XR150/XR350/XR550 Series Control Panels
March 2015

Version 108 Firmware Update

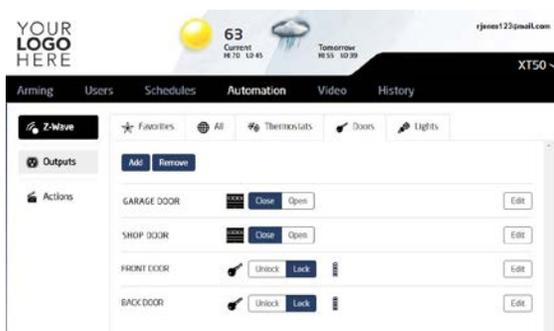
The XR150/XR350/XR550 Series Control Panels now support Z-Wave Garage Doors, such as the model Z-GD00Z-4. The Locks Screens of the 7800 Series Graphic Touchscreen Keypad, MyVirtualKeypad.com Browser and the Virtual keypad App have been renamed Doors and now display Z-Wave Garage Doors, Z-Wave Locks, and Door Devices.
